Council Assessment Panel Agenda & Reports

19 May 2025

**5.1 DEVELOPMENT NUMBER ID ID25003913 – MR JOHN AND MS HALEY MILLER –
69 HIGH STREET KENSINGTON**

DEVELOPMENT NO.:	25003913
APPLICANT:	John Miller and Haley Miller
ADDRESS:	69 HIGH ST KENSINGTON SA 5068
NATURE OF DEVELOPMENT:	Demolition of a dwelling (Local Heritage Place)
ZONING INFORMATION:	<p>Zones:</p> <ul style="list-style-type: none"> • Established Neighbourhood <p>Overlays:</p> <ul style="list-style-type: none"> • Airport Building Heights (Regulated) • Historic Area • Heritage Adjacency • Hazards (Flooding - General) • Local Heritage Place • Prescribed Wells Area • Regulated and Significant Tree • Stormwater Management • Urban Tree Canopy <p>Technical Numeric Variations (TNVs):</p> <ul style="list-style-type: none"> • Minimum Site Area (Minimum site area is 400 sqm) • Maximum Building Height (Levels) (Maximum building height is 2 levels)
LODGEMENT DATE:	17 Feb 2025
RELEVANT AUTHORITY:	Assessment panel/Assessment manager at City of Norwood, Payneham and St. Peters
PLANNING & DESIGN CODE VERSION:	P&D Code (in effect) Version 2025.3 13/2/2025

Figure 2 – Red is damage to walls, green is damage to ceilings & cornices, numbers and arrows externally indicate measured rotations

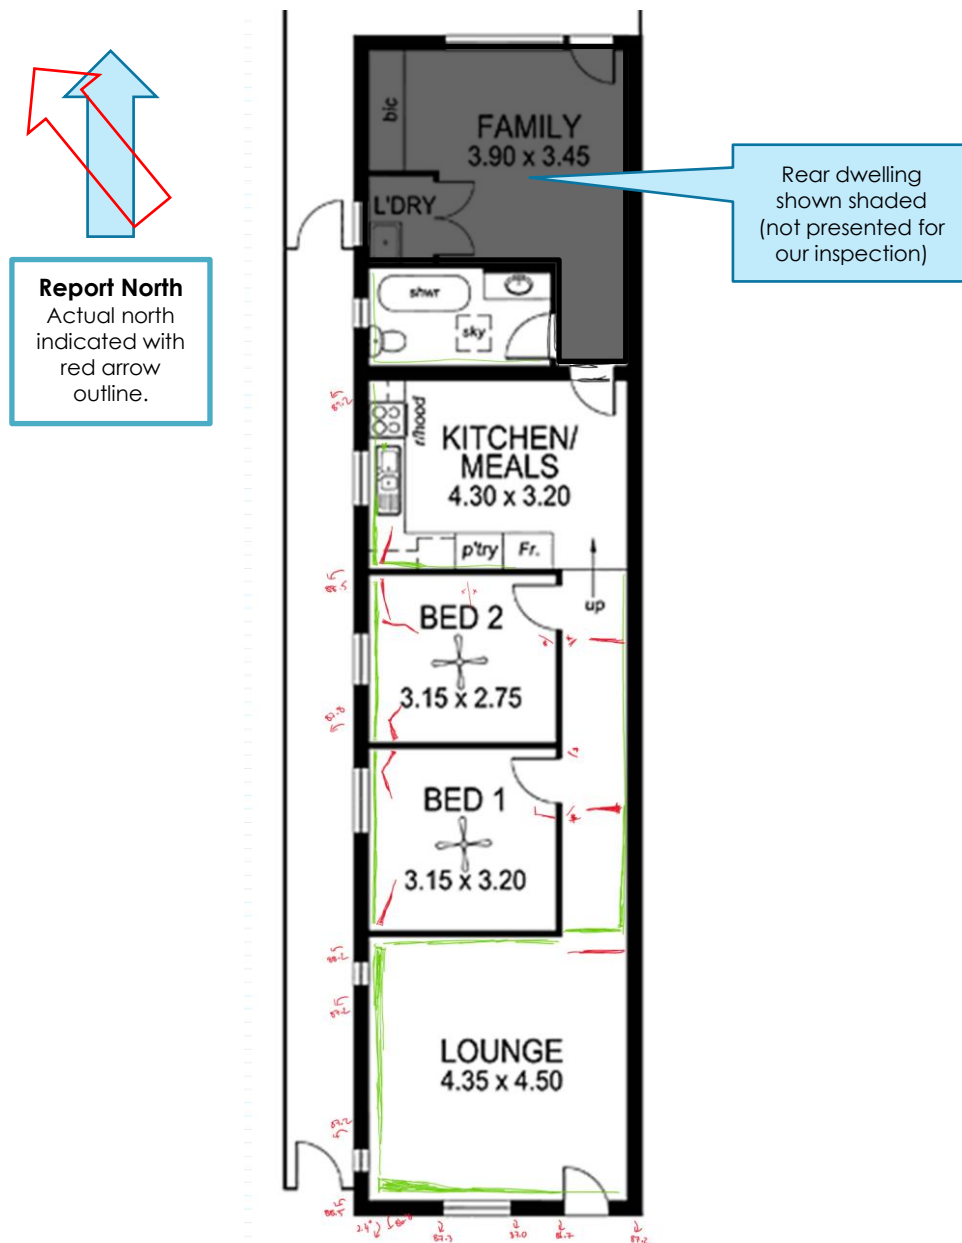
The most severe cracking, and that which we understand causes the applicant concern, was observed to the front lounge and along the western elevation (including the wall/ceiling junctions and the intersections between the western wall and internal return walls).

The southern (front) and western elevations' verticality was measured at various locations using a digital spirit level. The southern elevation was measured to be between 2.7° and 3.3° out of vertical alignment relatively consistently across its width. The western elevation was measured to be between 0.8° and 2.8° out of vertical alignment, with the severity of misalignment increasing from the rear to the front.

Figure 3 – Approximate extent of structure that may require reconstruction

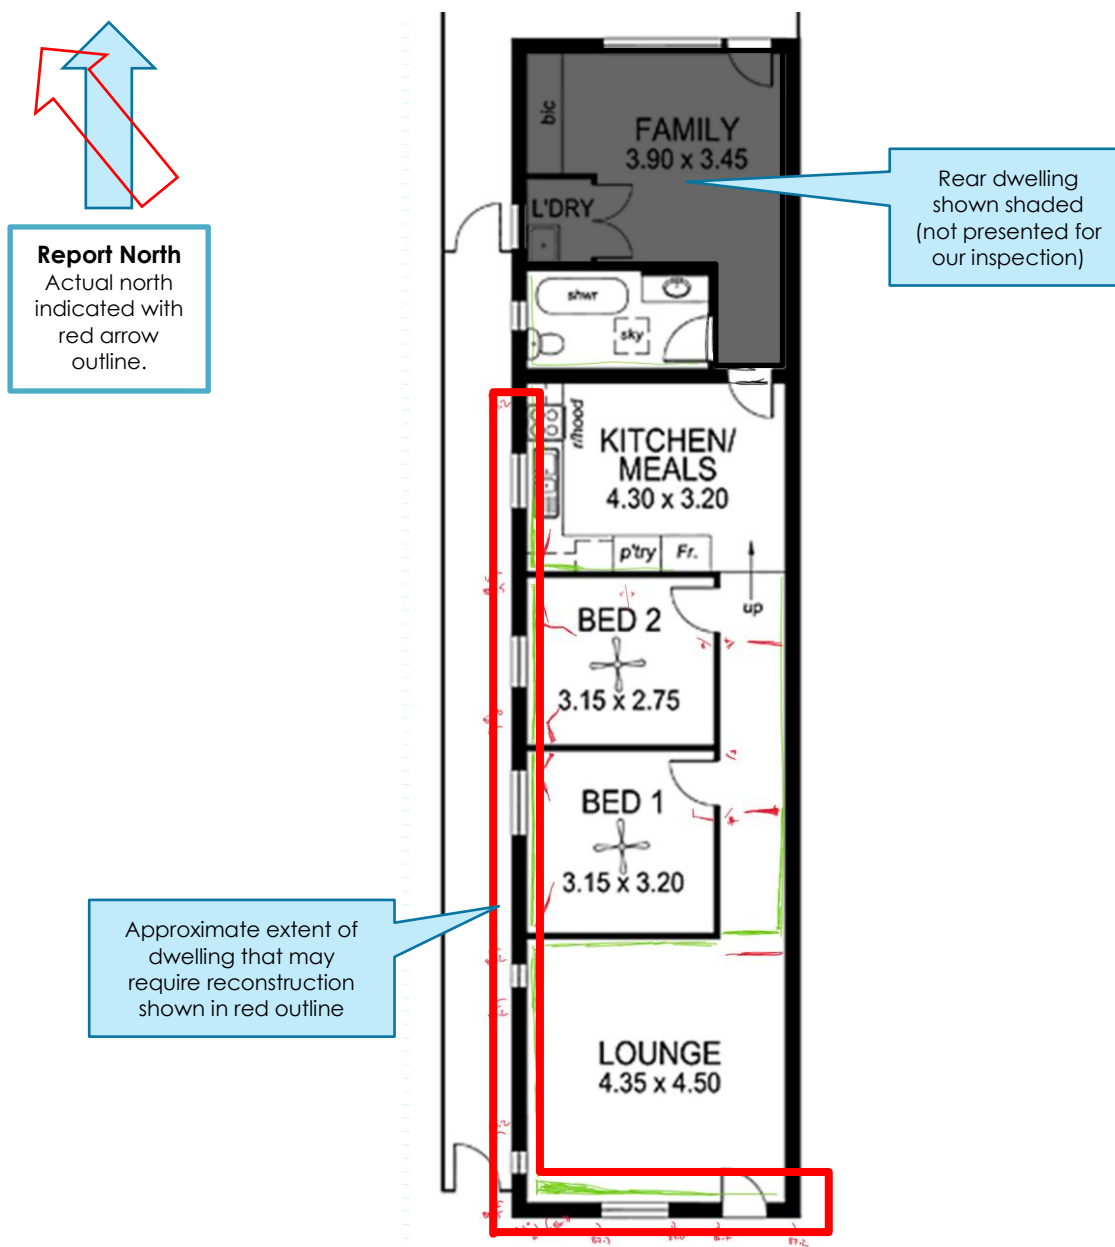
Therefore, in our opinion, for the purposes of the assessment of this application, it would be reasonable for stakeholders to allow for the affected walls to be reconstructed. The approximate extent of reconstruction works that we expect would be required is shown on Figure 3 on the following page. The reconstruction of these walls would also allow them to be underset with a damp proof course (refer also to further discussion regarding damp in the relevant sub-section of this report below).

If a reconstruction method is being contemplated, the southern and western elevations could be reconstructed upon the existing footings, on the existing footings that have been underpinned, or on entirely new footings. The method of reconstruction must consider the longevity of repairs – refer to further discussion regarding this in the following sub-section of this report.

2. It may be necessary to reconstruct the southern (front) and western elevations and local parts of the return walls to remediate the more severe movement that has occurred to these areas (refer to Figure 3 above and the associated discussion regarding realigning the existing walls).
